Addendum #1

Project Title: Capital Fund Program Improvements for **The Asbury Park Housing Authority**

Storm Door Replacement Work at Asbury Village & Washington Village located at 2 Atkins Avenue & 1259 Washington Avenue, Asbury Park NJ 07712

1 STORM DOOR DETAILS

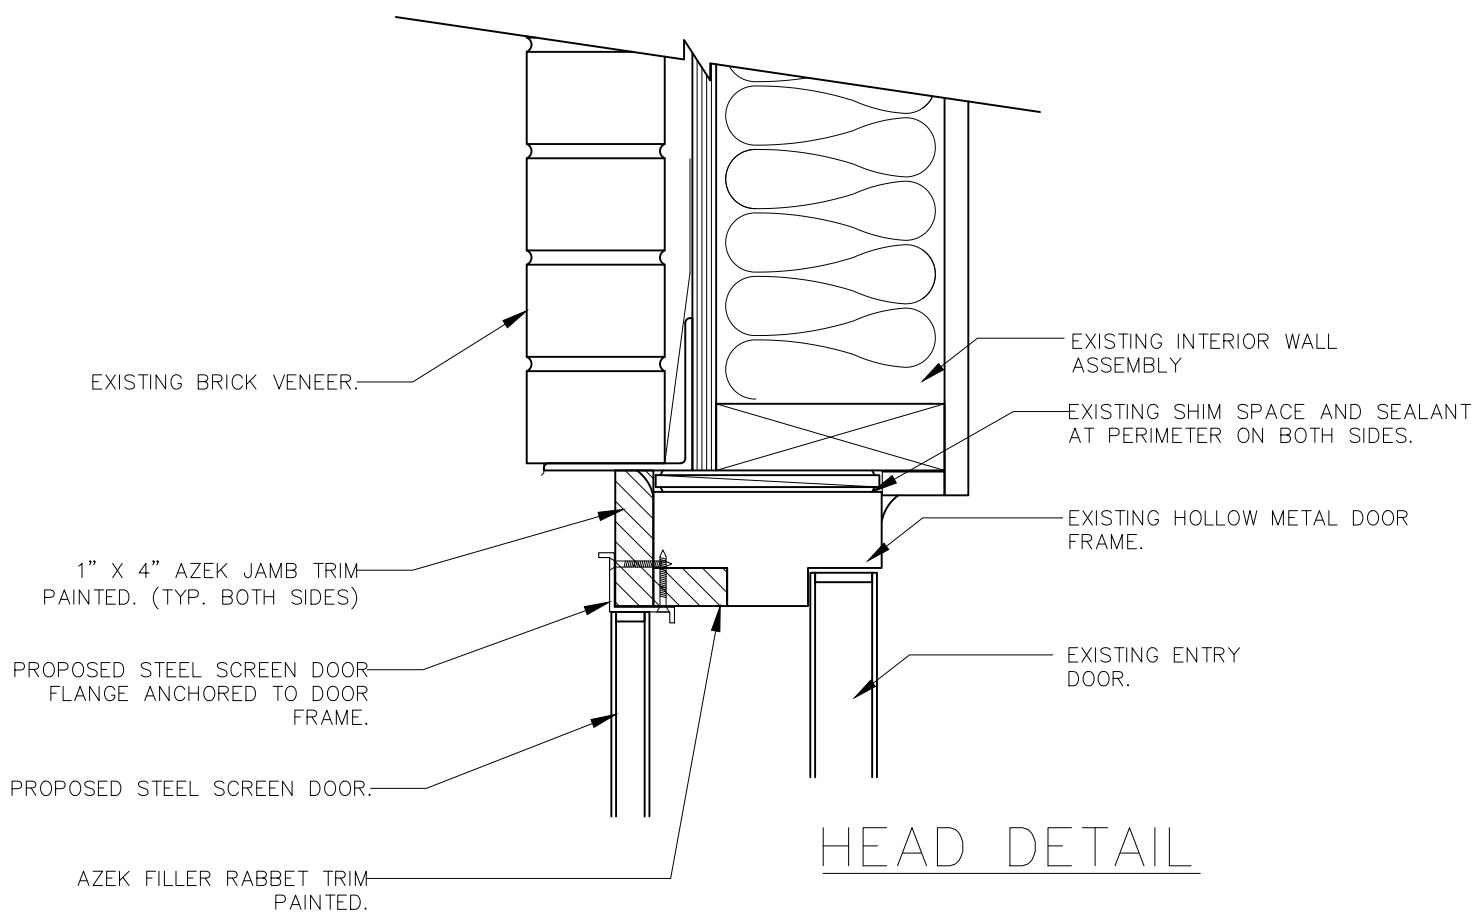
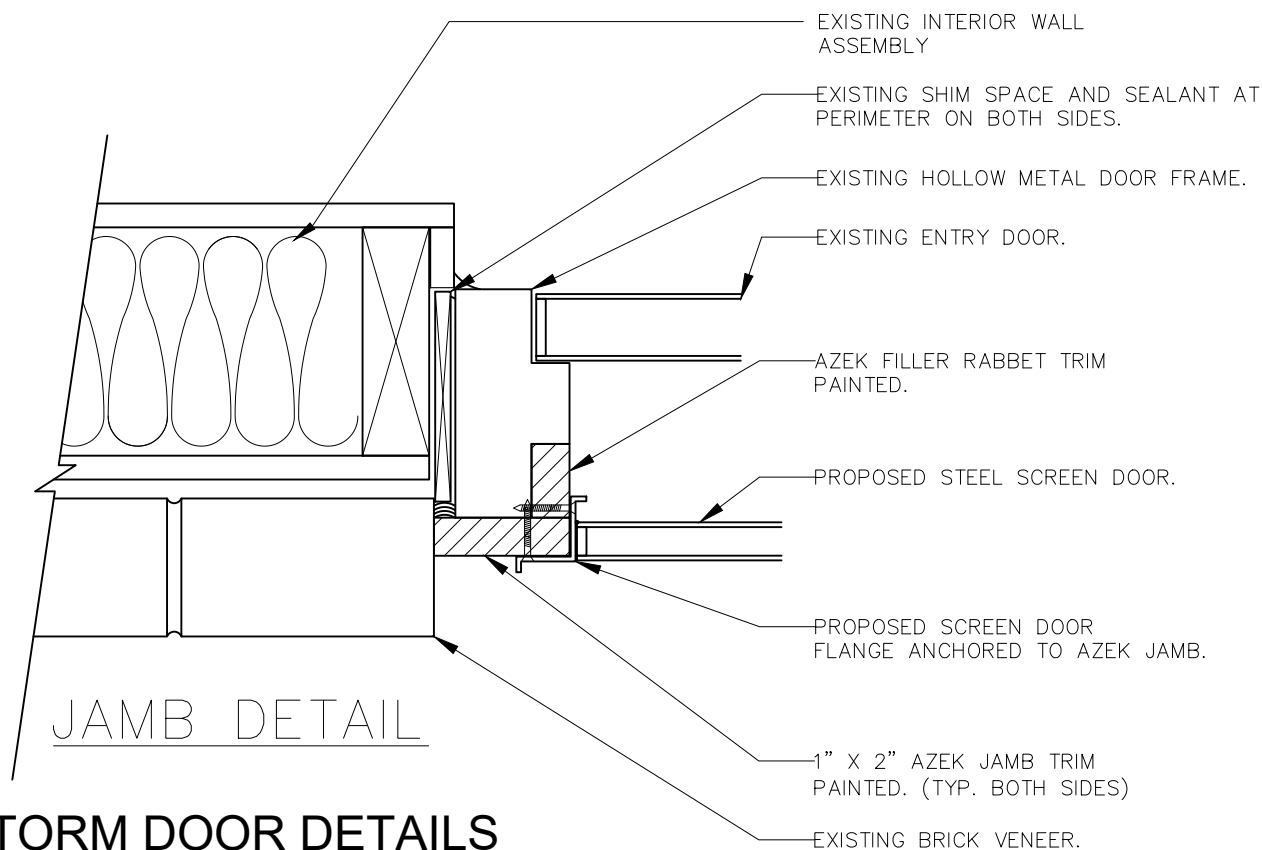
- * Each existing door opening both sites to receive new 1” x 4” Azek jamb trim. (openings & jamb size to be verified in field - 4” nominal Azek dimension to be custom ripped to steel door jamb size) The estimated jamb size to be true 2” width or slightly greater to steel header. All Azek jamb trim to secured with self-tapping stainless steel screws of 1-1/4” or greater length. All screws to be countersunk & cover plugged ready to receive priming and finish painting. See Addendum #1 - SK-1 sketch.

- * Each existing door opening both sites to receive new 1” x 6” Azek header trim. (openings & header size to be verified in field - 6” nominal Azek dimension to be custom ripped to steel door head size) The estimated head size to be true 4” width or slightly greater. All Azek jamb head to secured with self-tapping stainless steel screws of 1-1/4” or greater length to steel header. All screws to be countersunk & cover plugged ready to receive priming and finish painting. See Addendum #1 - SK-1 sketch.

- * Each existing door opening jamb screen attachment side to receive Azek filler trim in between jamb rabbet & new trim surround. All filler trim to be secured with self-tapping stainless steel screws. All screws to be countersunk & cover plugged ready to receive priming and finish painting. See Addendum #1 - SK-1 sketch.

2 STORM DOOR ELEVATIONS

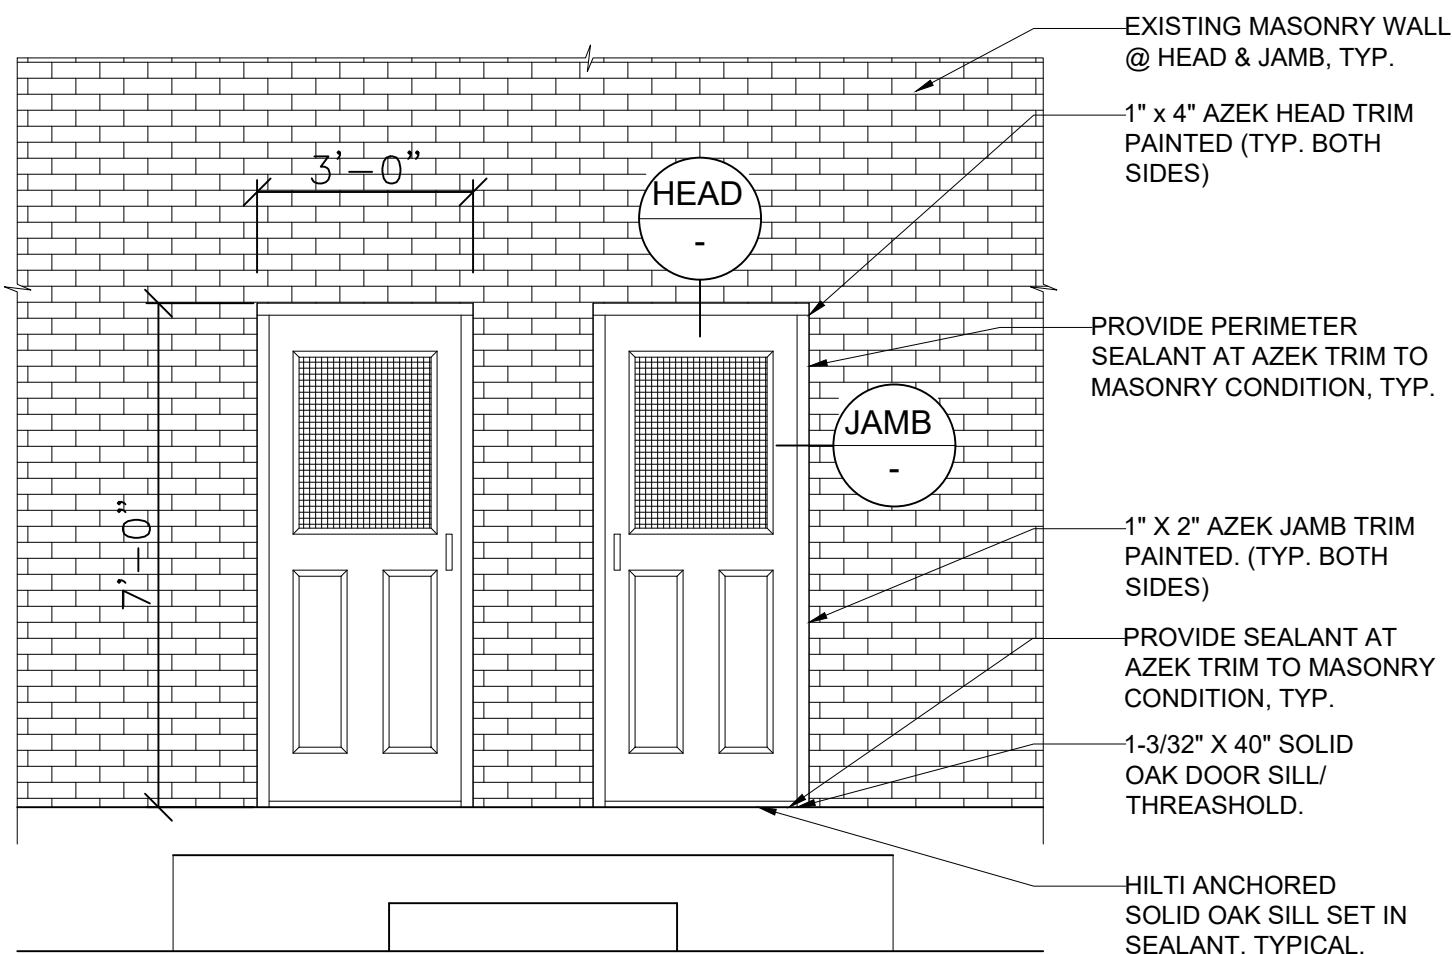
- * All screen doors to fit within the existing door frame openings with new brick / trim molding. Each screen door panel to be 32” wide x 80” high. All openings to be verified in field prior to final shop drawings / submittals being provided. All existing brick / trim molding placed over the existing steel frame (jambs & heads) are to be removed prior to new installation. All existing steel frames to be prepared for new trim installation.
